March 19, 2014

Subject: **Modification Request for the Individual Section 404 and Section 10 Permits, Section 401 Water Quality Certification and CAMA Major Development Permit** for the Wilmington Bypass from north of US 74/76 in Brunswick County to US 421 in New Hanover County. Federal Aid Project Nos. NHF-0017 (96) and STM-0017 (97), Division 3, TIP No. R-2633B. Debit \$475 from WBS Element 34491.1.2

PERMIT DRAWING SHEET 21 OF 73
 REV. 2014 03 06

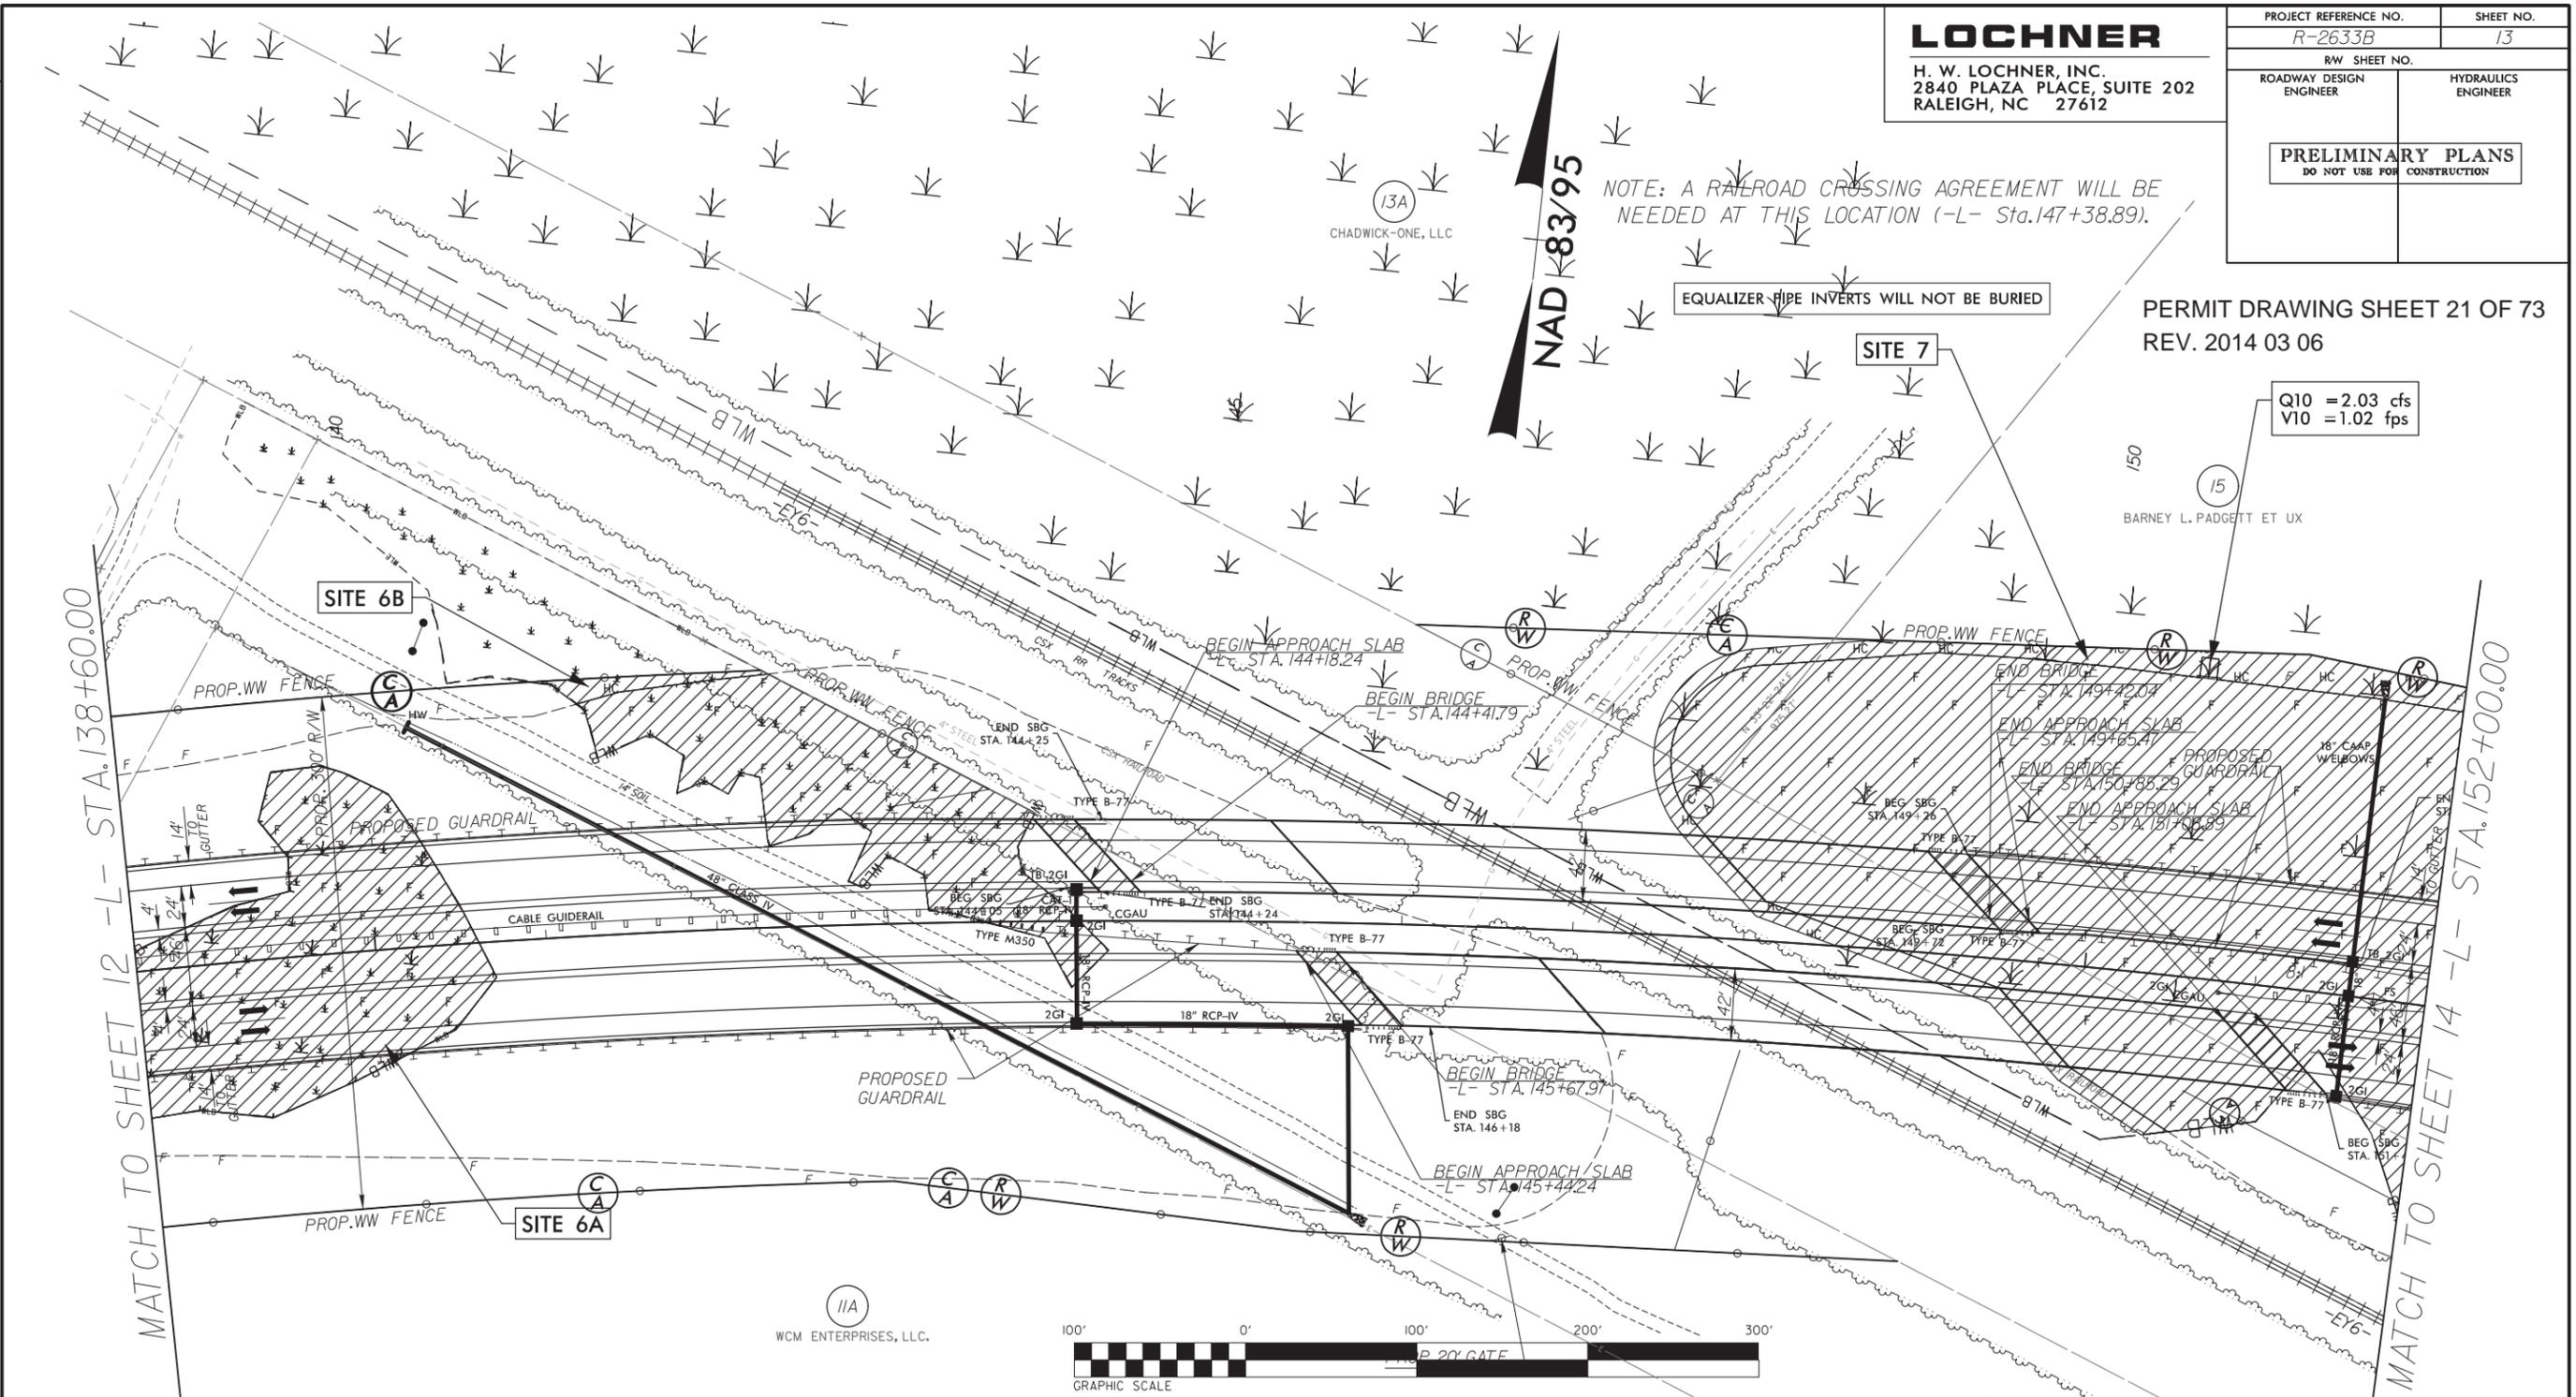
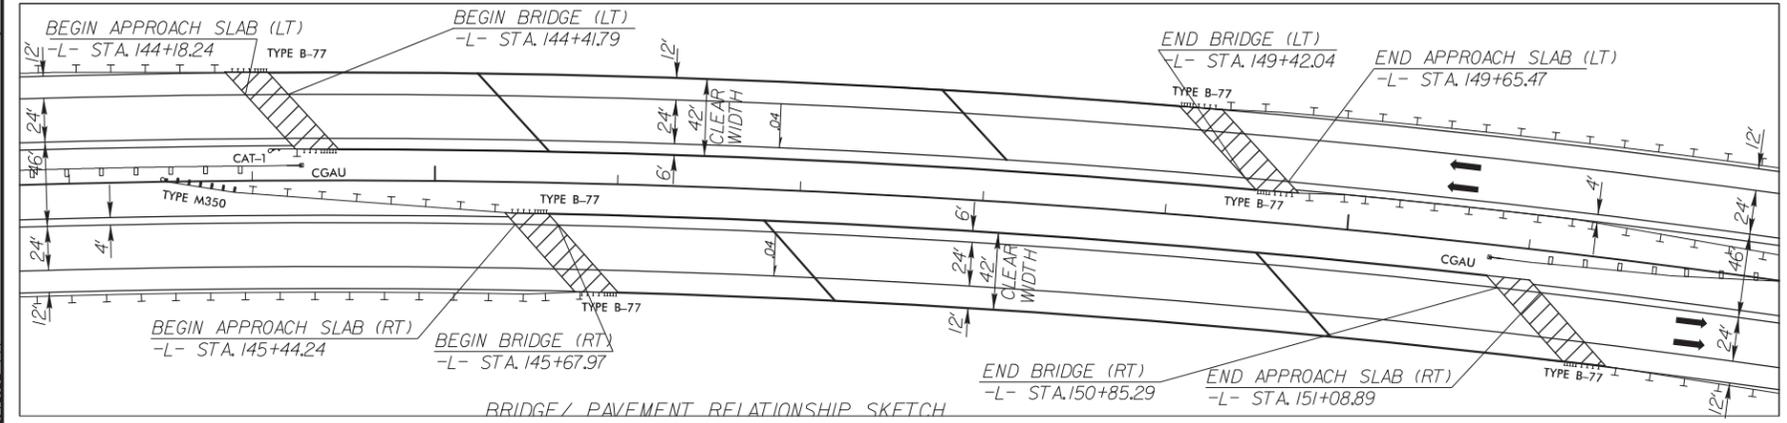
The last design at this site was a pair single span bridges proposed with MSE (mechanically stabilized earth) vertical wall abutments. It has been determined that extensive foundation work to make the abutments stable would have been required, therefore, increasing the cost. The current design of three span bridges with sloping abutments was proposed to eliminate this

foundation work, saving approximately 2 million dollars. The change in bridge and abutment types altered the slope stake line, which changed the impacts to the surrounding wetlands. As a result, there will be an increase of 0.02 ac of non-riparian wetland fill at Site 7 and a decrease in hand clearing of 0.14 ac. See revised permit drawings 21, 22 and 73 of 73. The new impact totals for this site are 10.57 ac. of non-riparian wetland fill and 0.84 ac. of hand clearing in wetlands.
